**GYROPOLIS  
REDEVELOPMENT**

**BLOOMINGTON, MN**

| ISSUED SET | CITY SUBMITTAL | 09/28/2022 |

## SITE PLAN

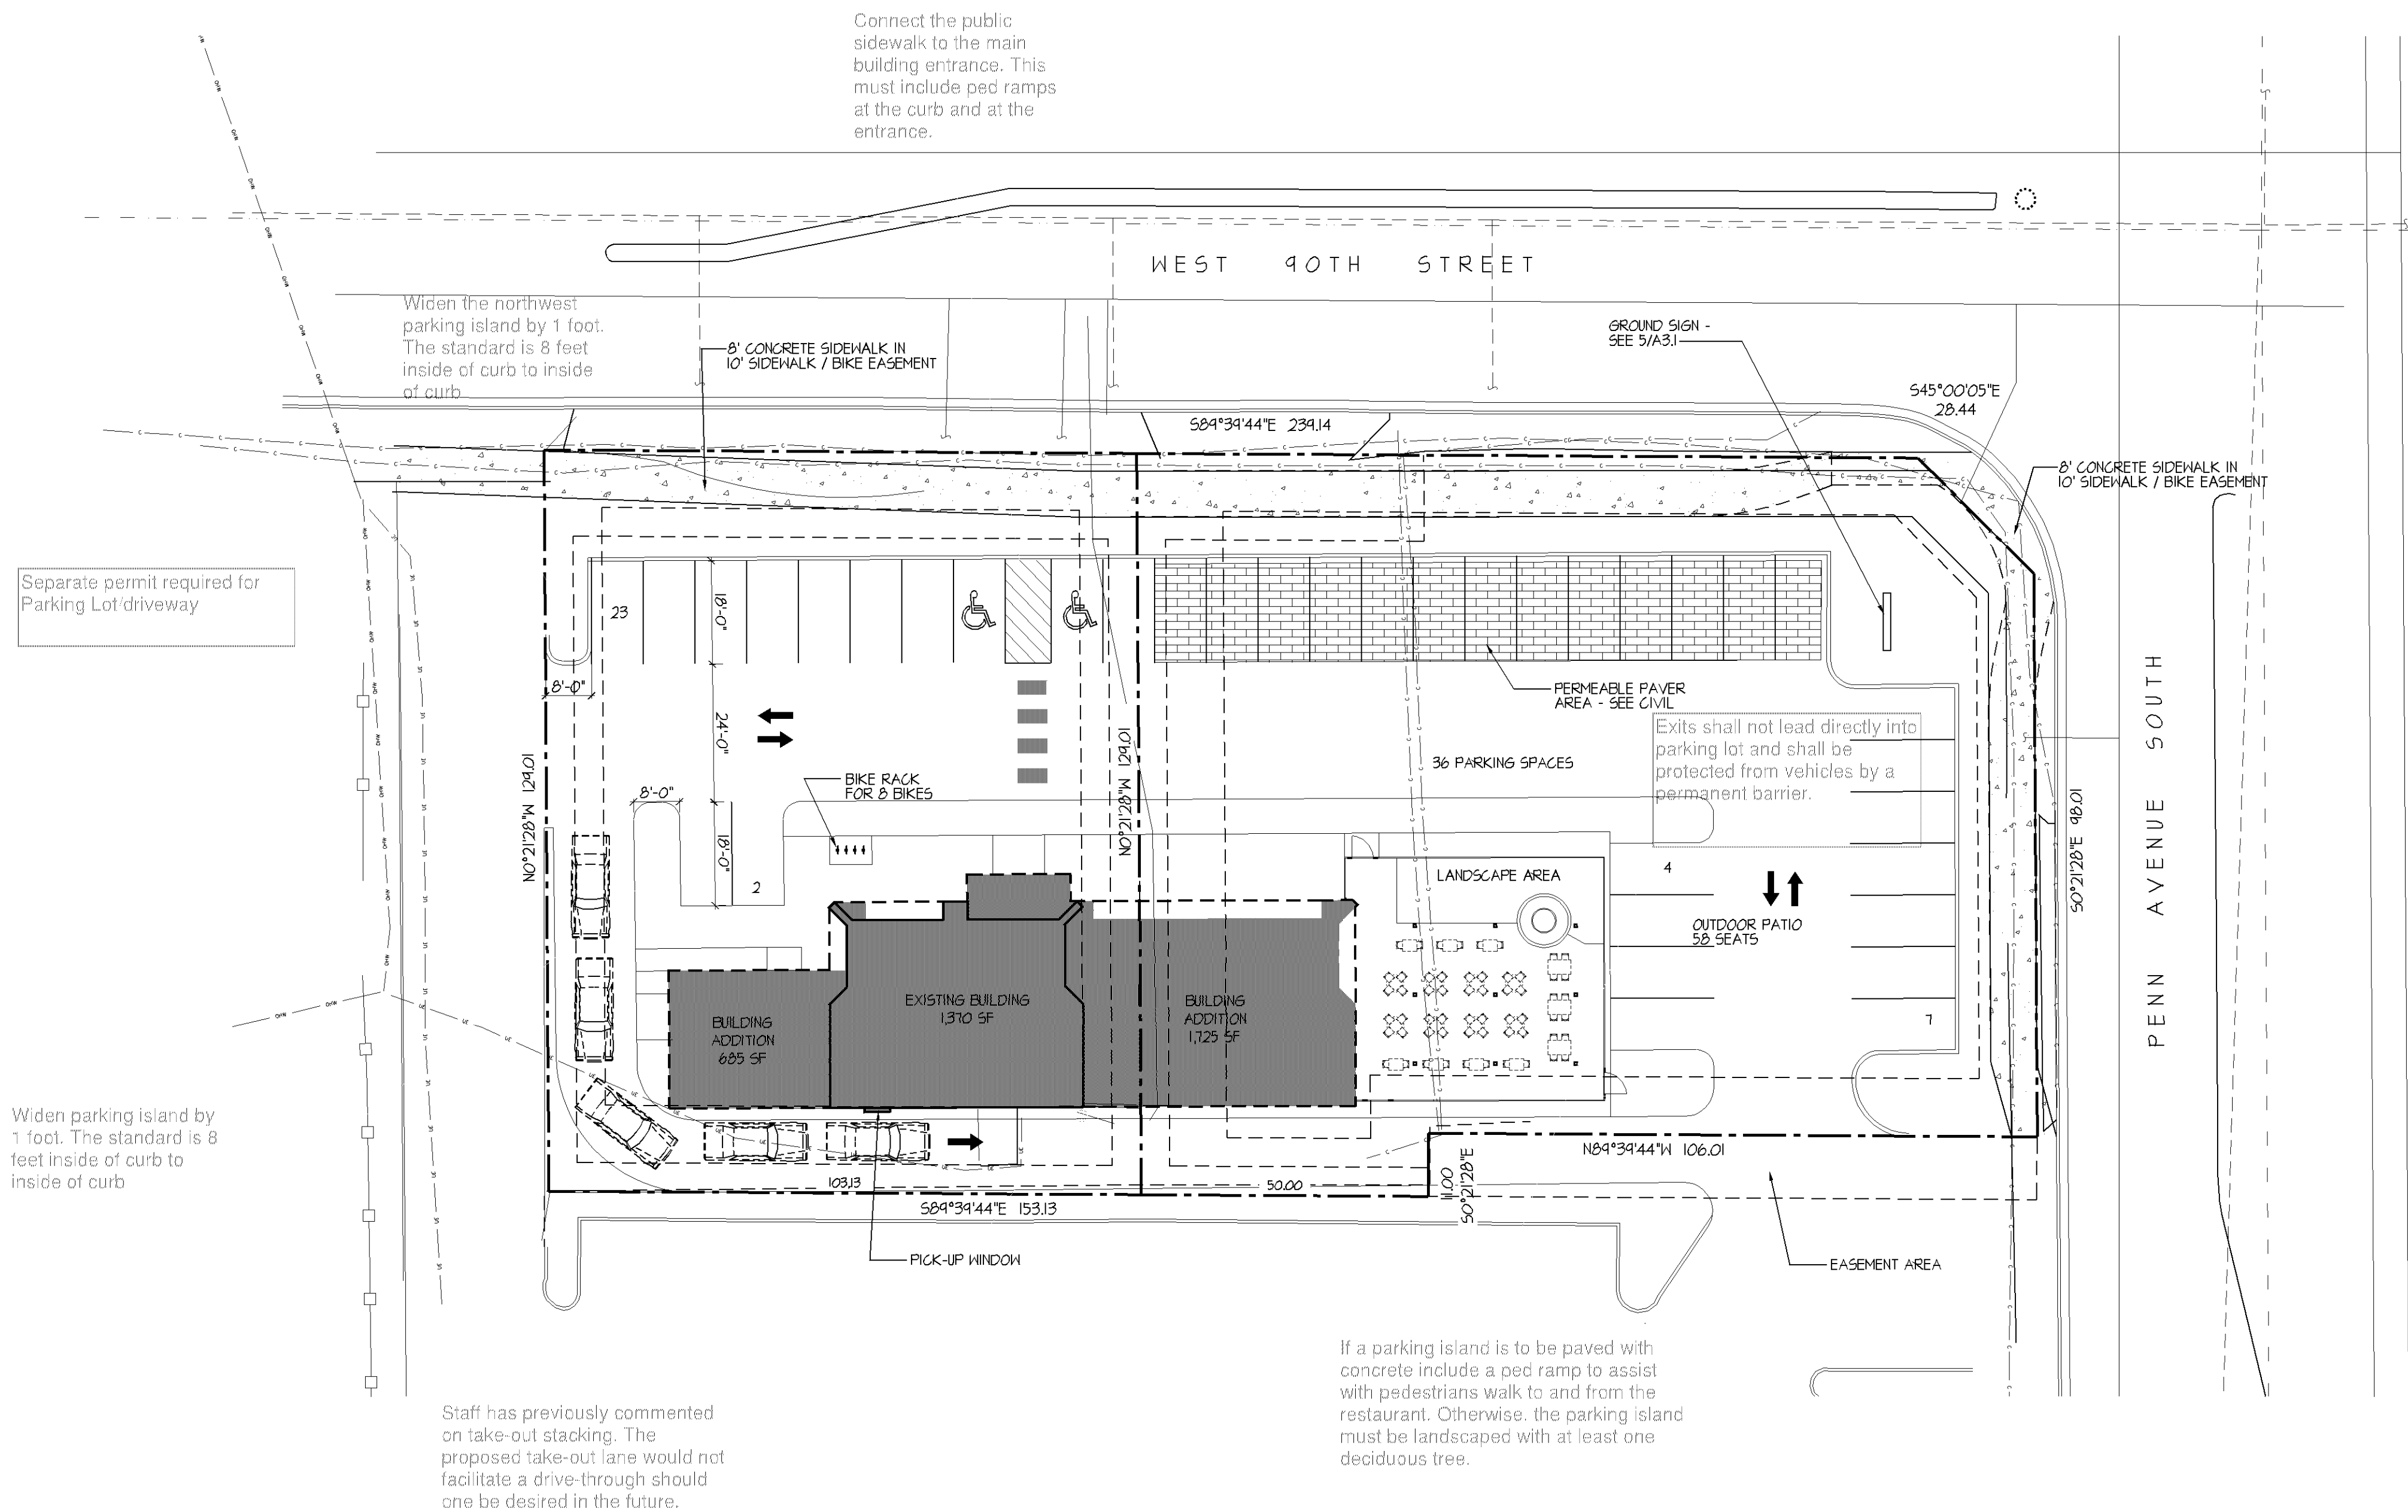
Appliances/cooking producing grease laden vapors requires a hood and suppression system connected to the

Entire space(s) must have fully Code  
complying sprinkler protection.

fire alarm panel(s), annunciator panel(s)  
and Knox box locations to be determined by  
the Fire Prevention Division.

ROOF PLAN

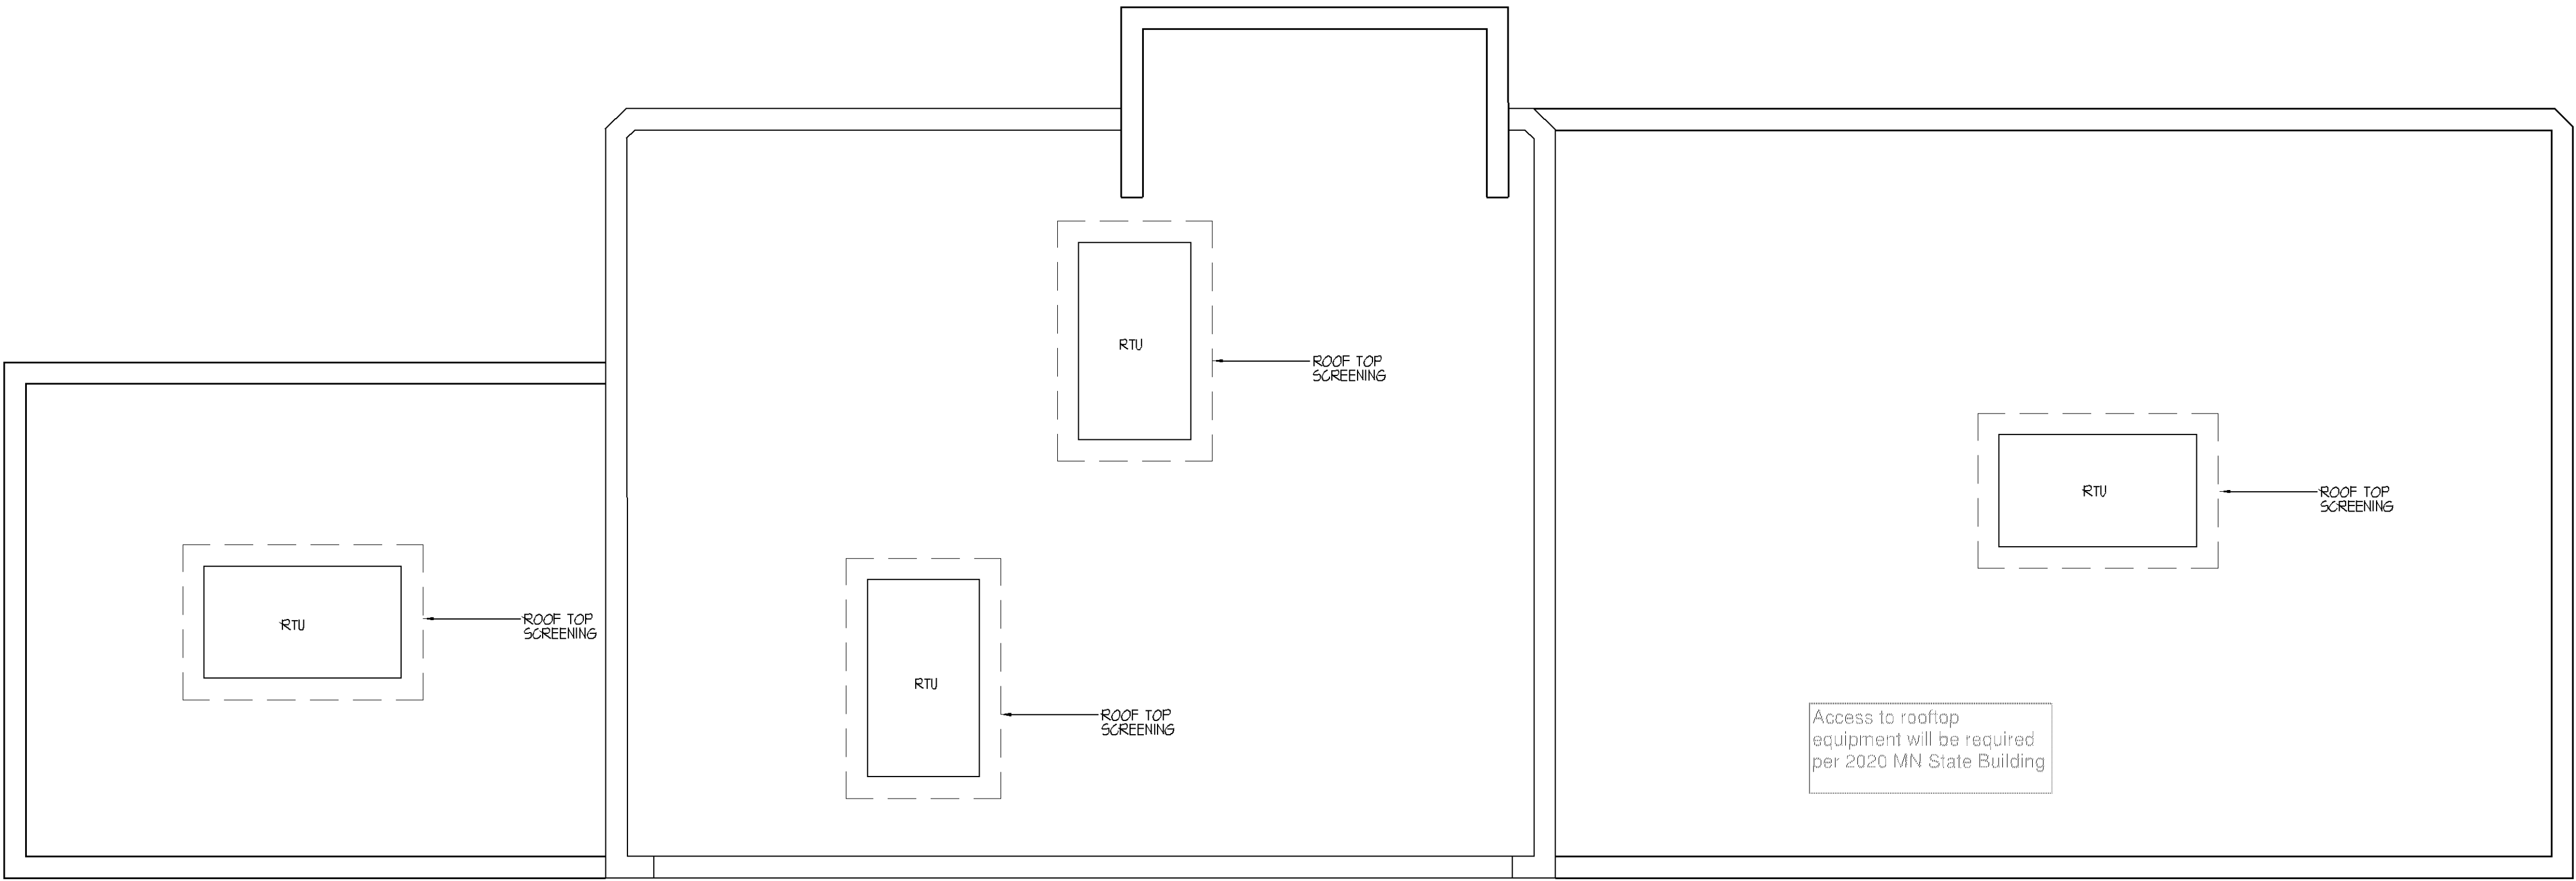
Restroom calculations will be calculated with patio seating and occupant load per MN State Building and plumbing code.
